APPLICATION NO.	FILING DATE	FIRST NAMED INVENTOR	ATTORNEY DOCKET NO.	CONFIRMATION NO.
10/821,031	04/08/2004	Nathalie Martin	VA30448	9237

Office Action Summary

DETAILED ACTION

Fig 1

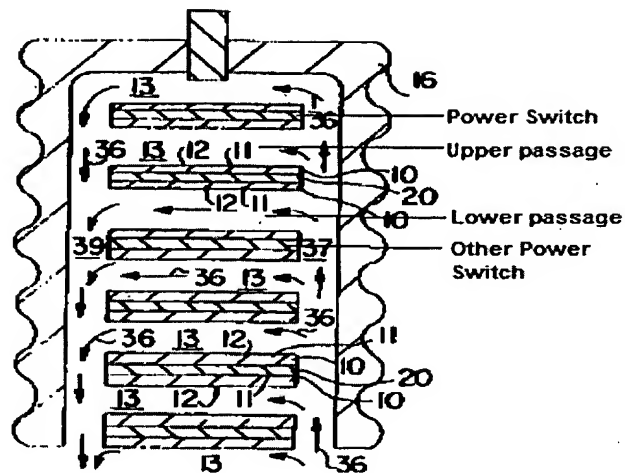
With respect to claim 1, Iversen teaches a power switching module (Column 2, Lines 1-4) comprising: at least one power module (20) placed above at least one other power switch (As illustrated in Fig 1), each power switch including upper walls and lower walls each adapted to be cooled through thermal conduction by a cooling medium (Column 1 Line 63 – Column 2 Lines 1); lower closed channels and upper closed channels configured to circulate a cooling medium along said lower walls and said upper walls, respectively (As illustrated in Fig 1), of said at least one power switch and of said at least one other power switch; and a lower passage in said power switch along and above said upper wall of said at least one other power switch, and an upper passage in said power switching module along and below said lower wall of said at least one power switch such that said upper walls are cooled by circulating a cooling medium in said lower passage and said lower walls are cooled by circulating a cooling medium in said upper passage (As illustrated in present office action Fig 1 below).

With respect to claim 2, Iversen further teaches that the lower passage and said upper passage have two ends interconnected to form a single cooling medium circulation circuit (As illustrated in Fig 1).

With respect to claim 8, Iversen further teaches that at least one end of either one of said upper passage and said lower passage and at least one end of either one of said lower closed channels and said upper closed channels are connected to a common inlet (36) connector for receiving the cooling medium and to a common outlet connector (38) for discharging the cooling medium (As illustrated in Fig 1).
